SUBJECT: COMANCHE PEAK NUCLEAR POWER PLANT, UNITS 3 AND 4
DOCKET NUMBERS 52-034 AND 52-035
RESPONSES TO REQUESTS FOR ADDITIONAL INFORMATION
NO. 2883, 3127, 3193, 3219, AND 3559

Response to Request for Additional Information No. 2883 (CP RAI #64)

RAI NO.: 2883 (CP RAI #64)

Figure 1 Height from Bottom of Basin to Centroid of Impulsive Pressure Distribution (Excluding Base Effects) for 31 ft deep Basin considering Expressions from ACI 350.3-06 and TID-7024 (note ACI 350.03 is equal to or greater than TID-7024 for all values of Basin Length)

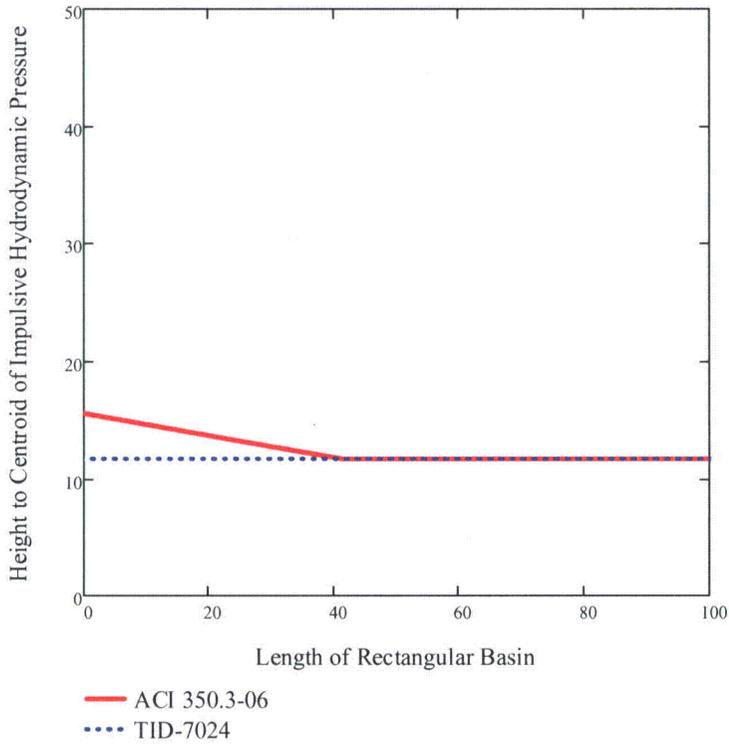
In combined license application (COLA), FSAR, Appendix 3KK (page 3KK-3), it is stated that the hydrodynamic effects of the water in the in the ultimate heat sink (UHS) structures is analyzed using the methodology of American Concrete Institute (ACI) 350.3-06. Describe the differences between the methodology of ACI 350.3-06 and the guidance provided in NUREG-0800 Standard Review Plan, (SRP) Section 3.7.3.II.14.A, and the references therein, and describe how the methodology used in the hydrodynamic analysis of the UHS basins differs from or complies with the SRP guidance.

NUREG-0800 SRP 3.7.3.II.14.A references ASCE 4-98, TID-7024, and NUREG/CR-1161 for acceptable techniques to assess hydrodynamic effects. ACI 350.3-06 was used for calculation of the hydrodynamic convective and impulsive masses, and associated heights and modeling was performed following the analysis procedures of ASCE 4-98. The procedures from ACI 350.3-06 used for design of the UHS are very similar or more conservative than the NUREG and associated documents as shown in the comparisons presented in Tables 1 and 2 and Figures 1 and 2 (attached). There is one part of Item F in Table 1 that was not included in the UHS hydrodynamic analysis. The omitted requirement is the influence of the vertical ground shaking on the lateral pressures on the basin walls. The increase in demands due to this omission is very small with no resulting impact on the adequacy of the design because it is accommodated by available margin.

Figure 1 Rectangular Hydrodynamic Regions used for Analysis

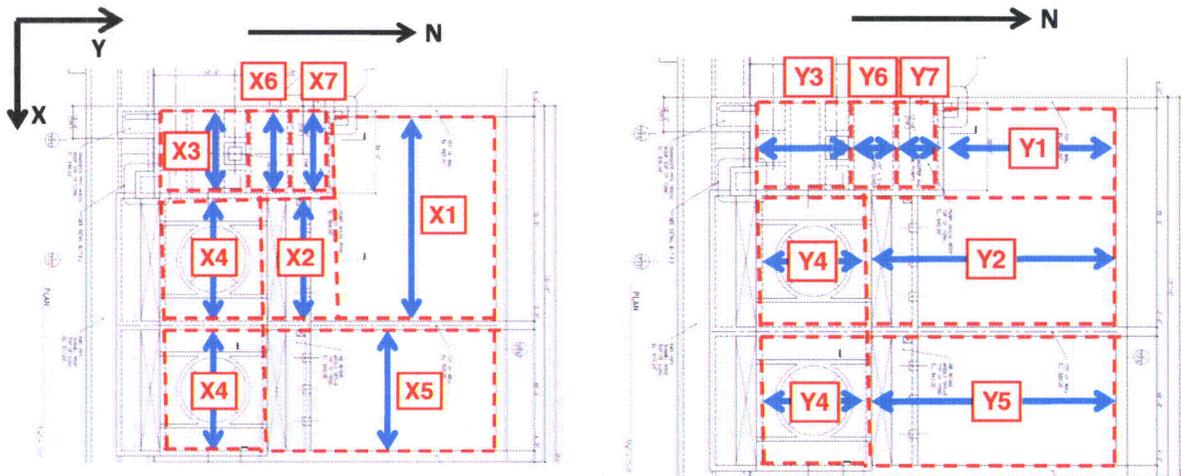
1. Clarification of how the convective mass of the water is treated in the analysis.
2. A description of each of the rectangular regions used in the analysis.
3. The convective frequencies for each of the regions.
4. The convective mass of the water for each of the regions.
5. The critical response parameters for the hydrodynamic analysis of the UHS basins.

The rectangular regions used for hydrodynamic calculations are shown in Figure 1. The regions were selected based on the clear dimensions of walls separating the basins, cooling tower cells, and pump room. Note the L-shaped region of basin 1 is separated differently for X- and Y-direction motion to adequately represent the conditions of a rectangular hydrodynamic region for which the expressions developed from ACI 350.3-06 or TID-7024 were derived.

Figure 3KK-4 Rectangular Hydrodynamic Regions Used for Analysis

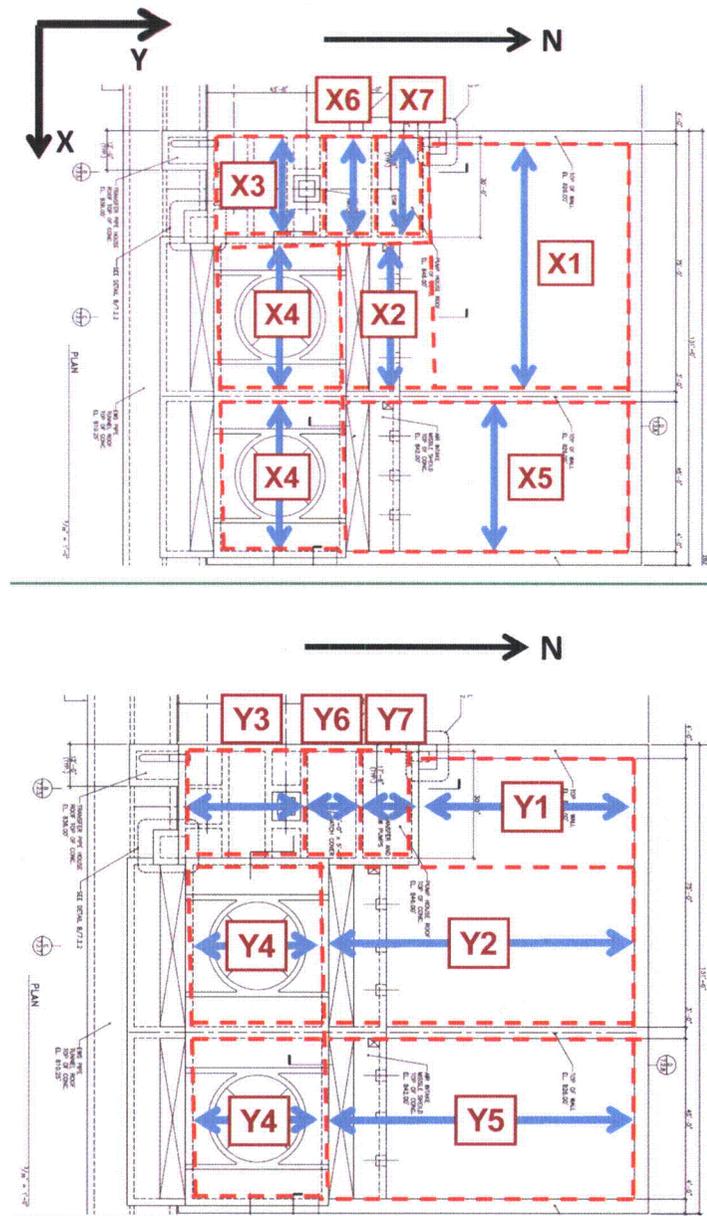
In COLA, FSAR Appendix 3KK (page 3KK-3), it is stated that the water within each rectangular region of the UHS structures is separated into impulsive and convective masses, but it is not required that the convective mass of the water in the UHS structures be modeled in the response spectra analysis to obtain seismic demands because the fundamental convective frequency is much lower than structural and soil frequencies.

The convective mass is included in the ANSYS response spectrum analysis using point masses and uni-directional springs. The mass is equal to the convective mass in Table 3KK-7 in the attached FSAR markup and the springs are assigned stiffness such that the mass-spring system has a frequency equal to the convective frequency in Table 3KK-7. Separate mass-spring systems are provided for all sloshing regions shown in Figure 1 below.
